**Transportation Engineering Design Standards (TEDS) Exception
Request**

City File No.: SPR-2008-248 (2701-313-06-002) ASSESSOR
Project: Schauenburg Expansion
Site Address: 2233 Sanford Drive -(139 Scarlet St) ASSESSOR
Applicant: Marflor Realty, LLC, John Kelleher
Representative: Austin Civil Group
Date: 02/12/2009
Parent Project:
Project Name: Schauenburger Expansion
City File No.: TED-2009-044

Re: TEDS Exception-2009-044 – Schauenburg Expansion

Transportation Engineering Design Standards (TEDS) Exception Approval / Denial Form

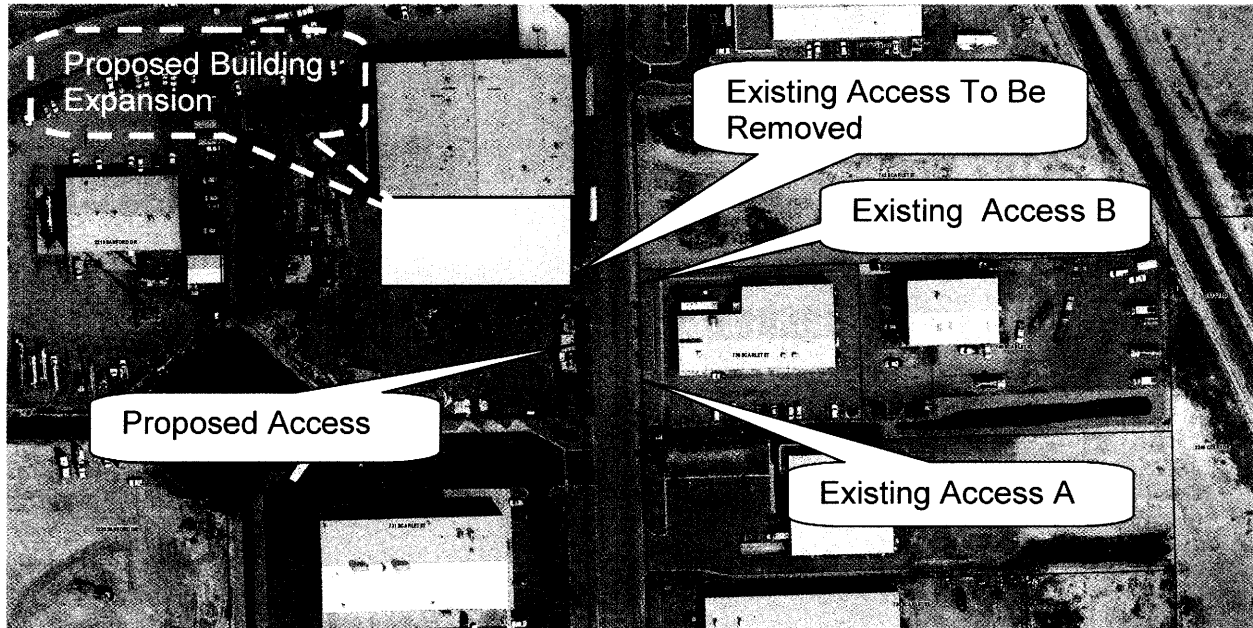
Request : An exception from the *City of Grand Junction's Transportation Engineering Design Standards (TEDS) Section 4.1, Access location*, which requires driveways shall be spaced a minimum of 50-ft apart, is being requested for this project.

The site is site located at 2233 Sanford Drive, in Grand Junction, Colorado. The access spacing variance is being requested to relocate their existing driveway south to account for a proposed building addition. The existing and proposed driveway access is located on Scarlet Street, as depicted in the photo below:

The proposed driveway access would be located approximately 20-ft north of "Existing Access A" and 21-ft south of Access B. The proposed location of the driveway location is critical for Schauenburg because it allows semi-

trucks to pull parallel to the south end of the building on the proposed concrete apron for fork-lift access to load and unload materials from the new expansion area, and leaves the area along the south property line available for outdoor storage and an overhead crane.

The TED's Exception Committee has approved your request as submitted.

Comment: The proposed driveway is onto Scarlet Drive which is a low volume, low speed commercial street. The driveway spacing requirements these types of commercial streets is proposed to be removed when the TEDS manual is updated.

The spacing of driveways is not easily controlled in established areas, such as this, where an existing building is expanding. It is desirable to allow the business to expand in a way that does not unduly complicate their operations, which would be the case if the driveway is located elsewhere.
